Work Order ID 160184

Item Name: Channel

APICAL INDUSTRIES, INC.	ENGINEERING CHANGE NOTICE NO. 03698				SHEET 1 OF 1	
	DWG NO. 647.0300	REV: N/C	PREPARED BY B. PETERS	DATE: 11/14/12	EFFECT ON DWG ☐ INC. ☒ UNINC.	
	DWG TITLE: CHANNEL					
	APPROVED BY: ENGR <i>[Signature]</i>	MFG <i>[Signature]</i>	QC <i>[Signature]</i>	EFF: NEXT ORDER		
TRANSACTION CODES (TC): A-ADD C-CREATE R-REVISE D-DELETE	REASON: ADDED ALTERNATE MATERIAL.				ECR: D-12-016

647.0310

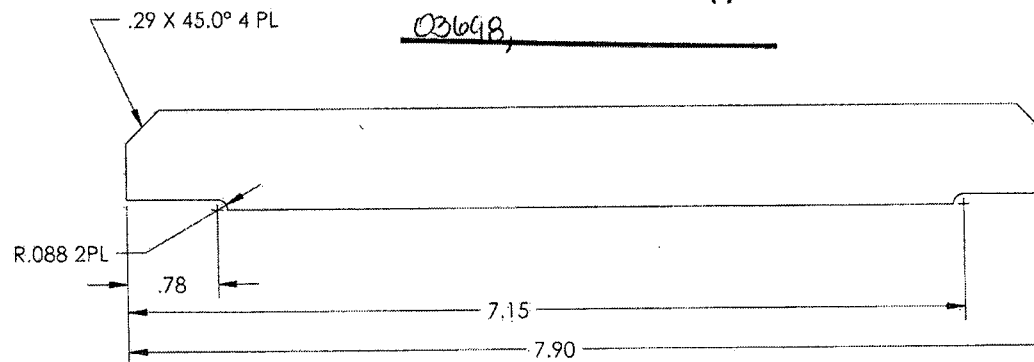
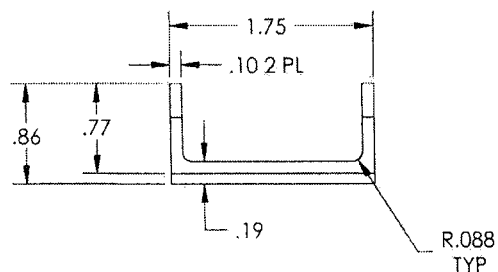
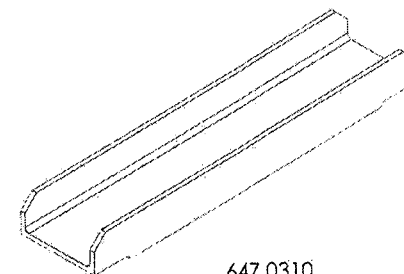
1 MATERIAL: 7075-T6 ALUMINUM PER AMS-QQ-A-225/9
ALTERNATE: 7075-T6511 ALUMINUM PER AMS-QQ-200/11
